Technical Bulletin

Subject: Wheel Alignment Specifications
for the Rear Axle

Number
9406

Models Affected: 911 Carrera Model Year 1995

Figure 1

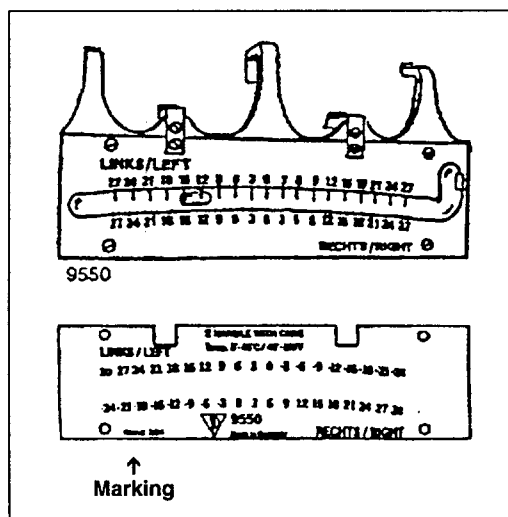
Also, the graduation plate of the spirit level 9550 for the measurement of the kinematic toe correction was modified.

Special Tool 9550: All dealers will receive a new graduation plate free of charge. For identification reasons this plate is marked "Stand: 3/94" (see Figure 1). The old plate has no date markings.

Remove the old graduation plate by removing the four (4) fitting bolts. Installed on the back of the tool is a plate without markings. This is installed for the tool's protection.

Before the new graduation plate is installed, remove the plastic protection film from the tool.

Note: Tighten the four (4) bolts lightly. The gauge does not need to be calibrated because fitting bolts are used.
